**Data Sheet Specification
Change for Intersil Products
ISL97682*, ISL97683*, and
ISL97684***

**Refer to:
PA12037**

Date: May 17, 2012

FIGURE 1. ISL97684 TYPICAL APPLICATION DIAGRAMS

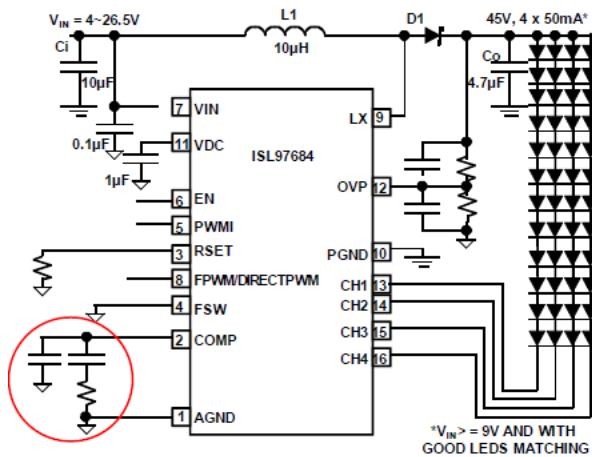
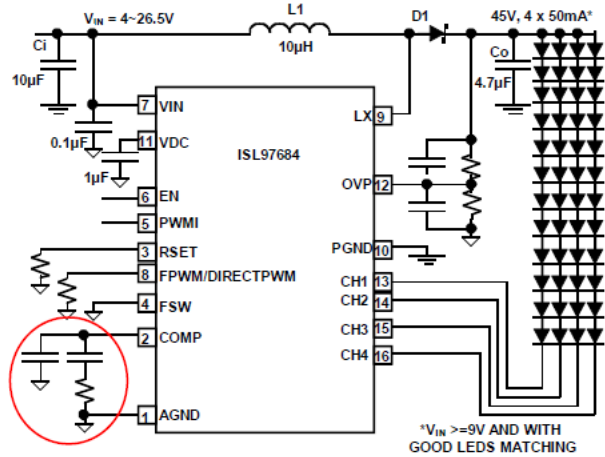
This advisory is to inform you that Intersil has changed the data sheet specification for the listed ISL97682*, ISL97683*, and ISL97684* products. The updates specify the resistor and capacitor values for the COMP pin in the *Figure 1 - Typical Application Diagrams* and change the FSW (Switching Frequency) voltage levels in the *Pin Descriptions* table and *Switching Frequency and PWM/PFM Mode* section of the data sheet. Details regarding the changes are contained on the following pages. The updated data sheet is available on the Intersil web site at <http://www.intersil.com/content/dam/Intersil/documents/fn76/fn7689.pdf>.

- Figure 1 - Typical Application Diagrams (Page 1):

Change From:

FIGURE 1. ISL97684 TYPICAL APPLICATION DIAGRAMS

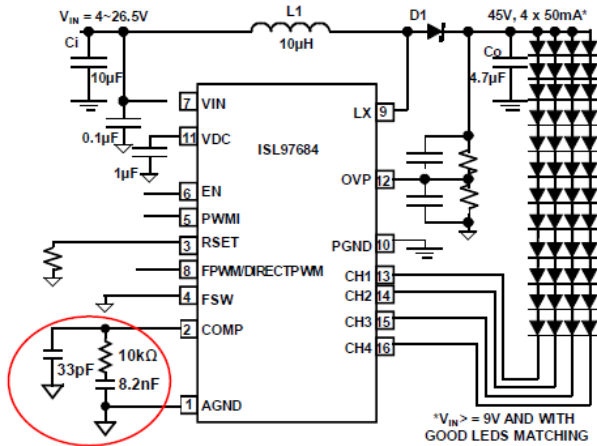
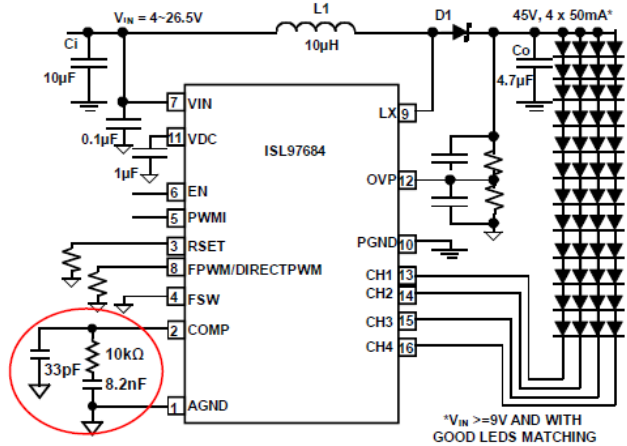
Change To:
